Title: **QUALITY AUDIT**

**Road Safety Audit, Access Audit, Cycle Audit and Walking  
Audit.**

**Ballyoulster KDA SHD – Phase 1 Residential Development,  
Celbridge , Co. Kildare**

Report reference: **1485R01**

Drawing 180221-DBFL- Z0-SP-DR-C-2001 Rev P02, Main Access Road Ch 90 to 150.

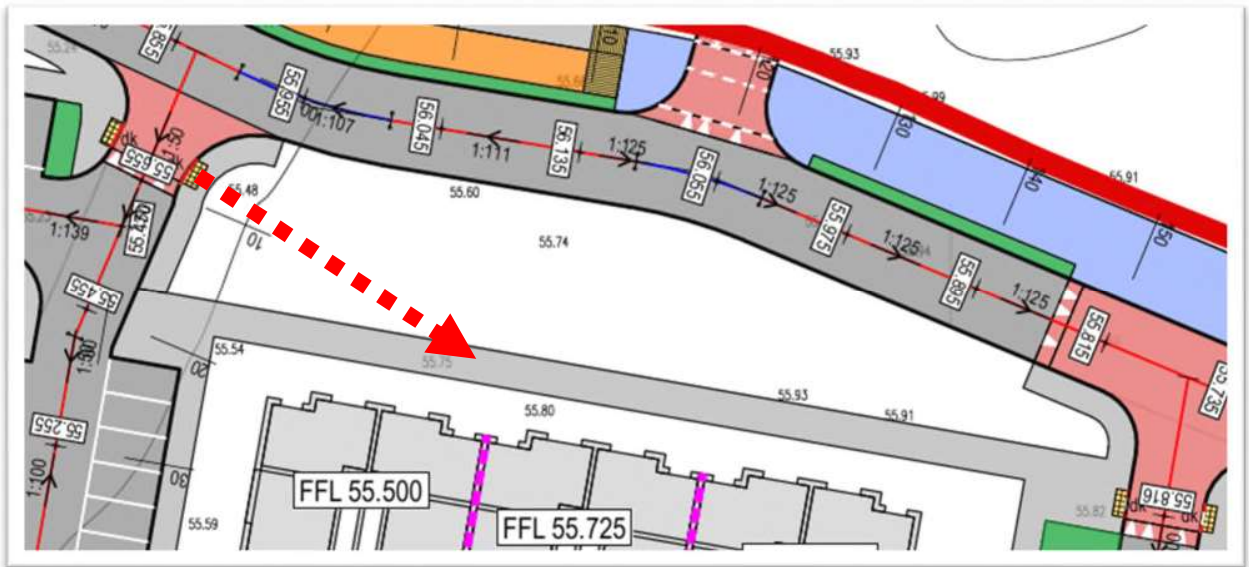
The footpath does not follow the edge of the carriageway along the access road between Ch 90 and 150. There is a risk that pedestrians will take the most direct route from Shinkeen Road and will travel through the green area. This could lead to slips and falls.

It is recommended that the footpath network follows desire lines as much as practicable.

3.1	Yes	No	Hard standing with drop kerb provided to allow access to / from the cycle facility	Yes
3.2	Yes	No	The footpath has been aligned to respect drainage design requirements. Obstructions by way of planting will be provided in this area with the aim of making this route through the green area less convenient	Yes

Drawing 180221-DBFL- Z0-SP-DR-C-2001 Rev P02, Internal road with horizontal traffic calming build out. Chainage 190.

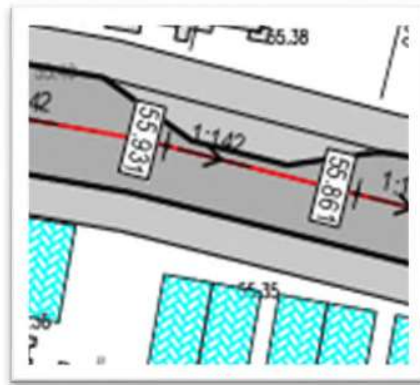
There is a proposed build out on the internal road at the first section of the development to the East of Shinkeen Road. It is unclear if drivers using the on-curtilage parking on the opposite side of the carriageway will have enough room to manoeuvre given the limited carriageway width.

Carry out a swept path analysis to ensure that the manoeuvre can easily be carried out and if not relocate/reprofile the buildout.

3.3	Yes	Yes		
3.4	Yes	Yes		
3.5	Yes	Yes		
3.6	Yes	Yes		
3.7	Yes	Yes		
3.8	Yes	Yes		
3.9	Yes	Yes		
3.10	Yes	Yes		
3.11	Yes	No	In the short term prior to continuous pedestrian facilities along the southern side of Dublin Road, pedestrians seeking access to the proposed residential units will be directed along this section of footpath. Celbridge bound pedestrians will be directed to the proposed traffic signals.	Yes

Drawing 180221-DBFL- Z0-SP-DR-C-2001 Rev P02, Shared use path at north eastern end of the site.

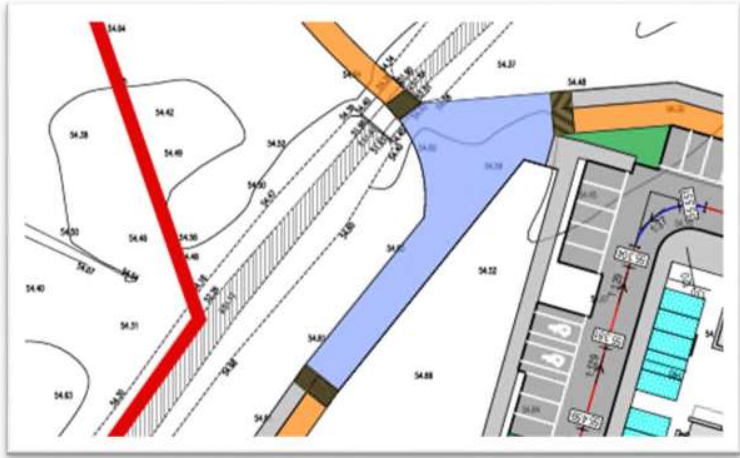
There is a long section of shared use pedestrian/cyclist path at the north eastern side of the site. The reason for such a long length is unclear. Cyclists will pick up speed and if they collide with pedestrians the severity of the injuries could be higher.

It is recommended that the shared area be reduced to locally around the junction.

Drawing 180221-DBFL- Z0-SP-DR-C-2002 Rev P02, Dublin Road cycle track.

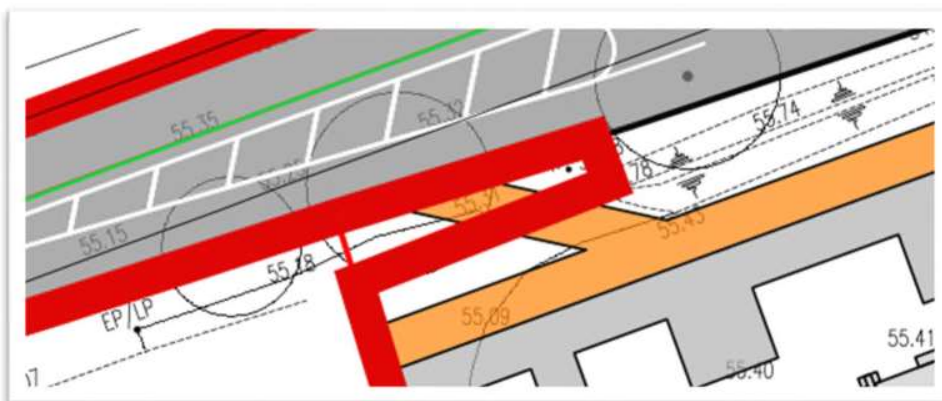
It is proposed to merge cyclist back onto the Dublin road at the western side of the development at an acute angle. There is a risk that cyclists may not check for oncoming traffic and drivers might not have sufficient visibility to merging cyclists given the berm and the vegetation.

It is recommended that the interim tie-in be perpendicular to the Dublin Road whereby cyclists will have to stop and look right. Suitable visibility splays should be provided to this temporary merge point.

Alternatively the temporary merge should be omitted and suitable fencing be placed along this boundary to ensure that pedestrian and cyclists use the signalised junction to access the Dublin Road.
